FEDERAL PUBLIC NOTICE

Subj: PERMIT MODIFICATION REQUEST FOR MILCON P-518 X-RAY WHARF
IMPROVEMENTS BERTH 1, U.S. NAVAL BASE GUAM

ENCLOSURE 1
MILCON P-518 X-RAY WHARF IMPROVEMENTS BERTH 1, U.S. NAVAL BASE GUAM
REVISED NATURE OF ACTIVITY DESCRIPTION

Figure 1: Design Dredge Plan

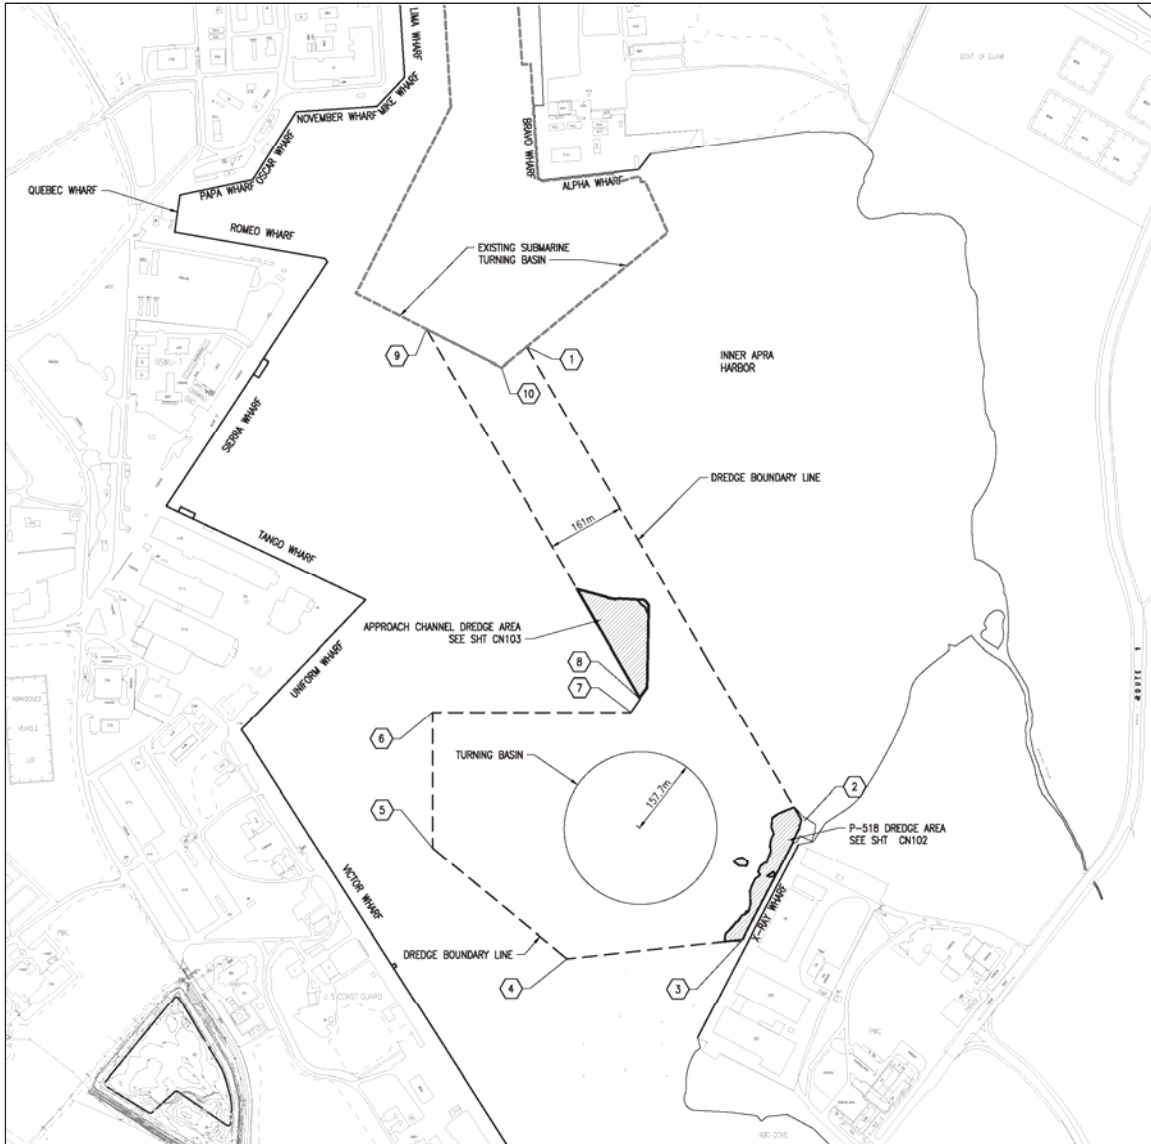
Dredging is required to achieve adequate depth for the T-AKE class ships to berth at X-Ray Wharf. The dredge footprint includes an approach channel within Inner Apra Harbor and a turning basin/berth area in front of X-Ray Wharf. As shown in Figure 1 and Table 1, the design dredge plan accounted for approximately 26,500 yd³ within the approach channel area and 24,500 yd³ for the berth outboard of the new wharf face. The project's original total dredge quantity was 51,000 yd³.

Figure 2: August 2016 Pre-Dredge Survey

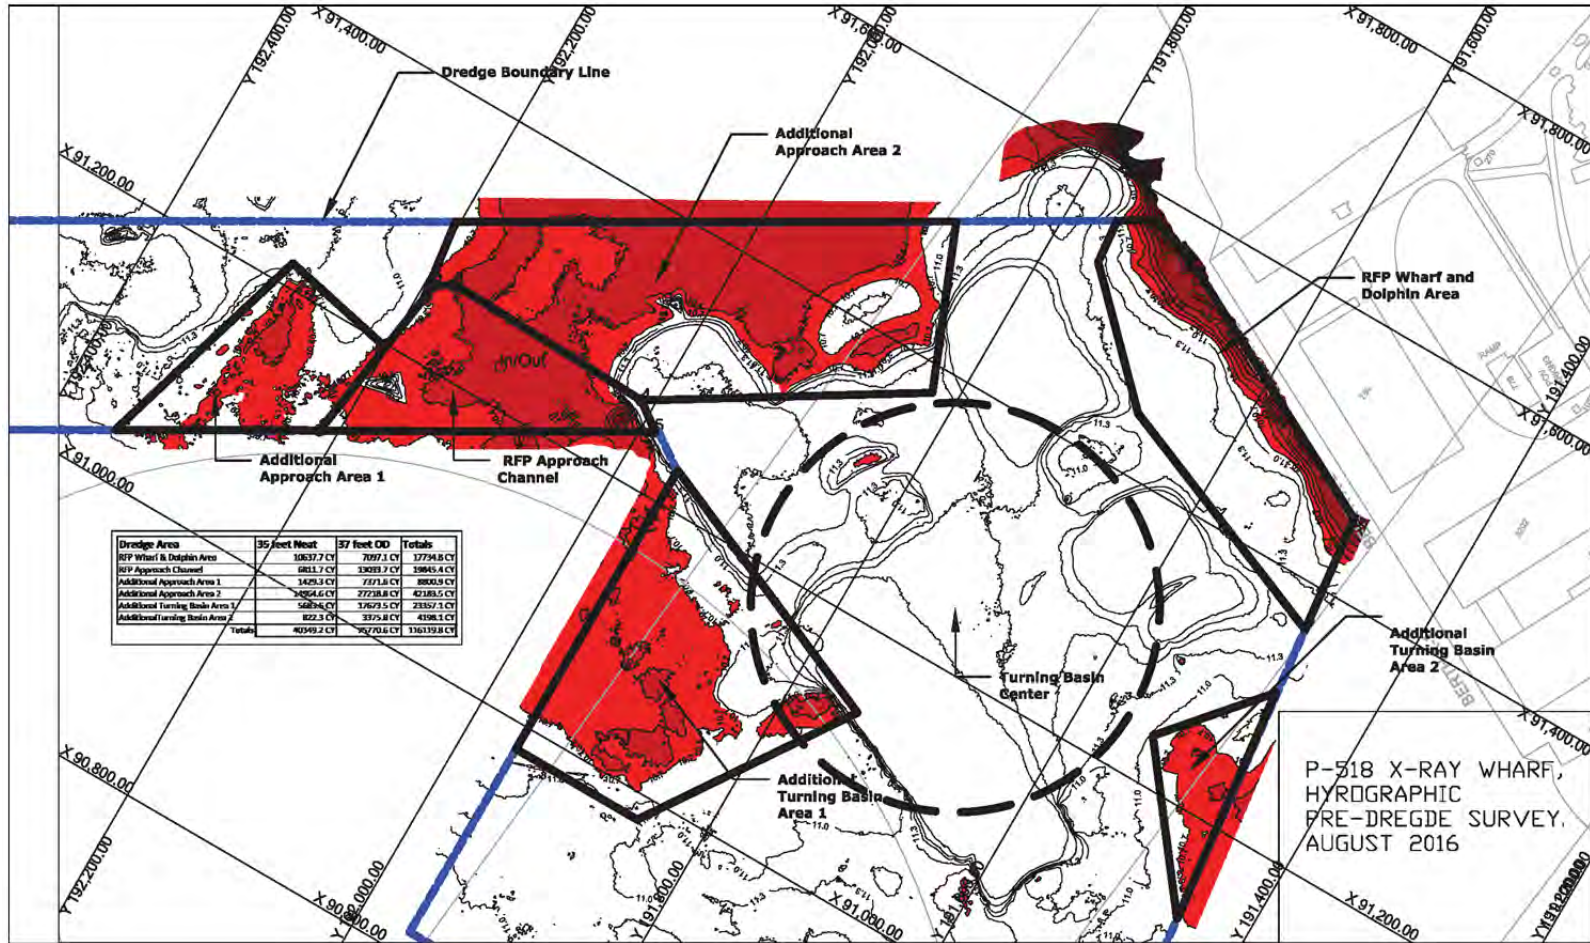
In August 2016, the construction contractor performed a pre-dredge hydrographic survey and the results identified four additional areas within the approach channel and turning basin required to be dredged to achieve -35' MLLW. As shown in Figure 2 and Table 2, the revised dredge plan includes the original Wharf Area and Approach Channel dredge areas with new dredge areas: Approach Area 1, Approach Area 2, Turning Basin 1, and Turning Basin 2. The revised total dredge quantity is approximately 116,120 yd³ and includes a maximum 2-ft overdredge allowance.

The discrepancy between the design and revised dredge quantities is due to the hydrographic data used to develop the design dredge volumes which came from several sources since one source that covered the entire P-518 project area was not available. This resulted in potential differences because each set of data had to be converted to a common datum that could be used for all the sets. In addition, there were areas that did not have coverage based on the available data and the design dredge quantities had to be interpolated between sets. The data set developed by the contractor from the August 2016 pre-dredge hydrographic survey is a continuous data set unlike the piecemeal data set used for the design dredge plan.

Figure 3: 2011 and 2016 Sediment Characterization Sampling Locations

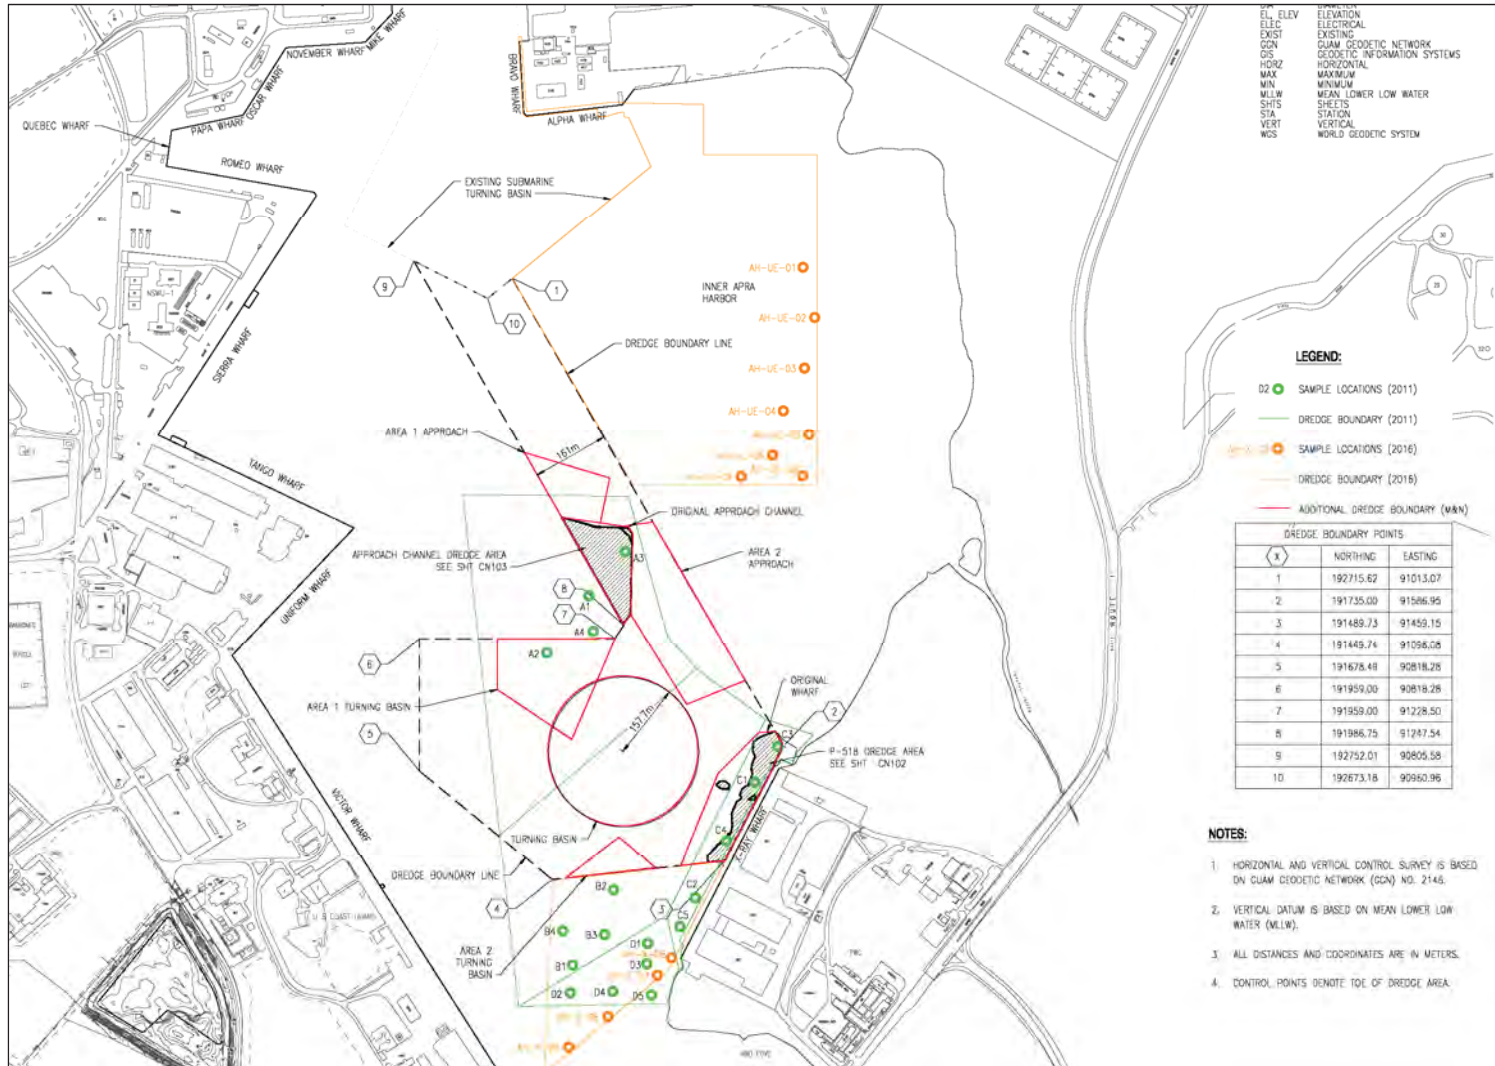
Additional sediment sampling was conducted in the upper east region of Inner Apra Harbor during June 2016 and is representative of the remainder of the Area 1 and Area 2 Approaches. Refer to Figure 3 for the locations of the 2011 sediment sampling sites used for the April 2014 report and the 2016 sediment sampling sites. The Draft Dredged Material Evaluation for Ocean Disposal: Upper East Inner Apra Harbor, Delta/Echo, Sierra/Tango Corner, X-Ray, and Victor Wharves, Apra Harbor, Guam contains the results of the physical, chemical, and biological testing for the upper east area. It is anticipated that all 116,120 yd³ of the dredged material generated from the P-518 project will be suitable for placement at the G-DODS.
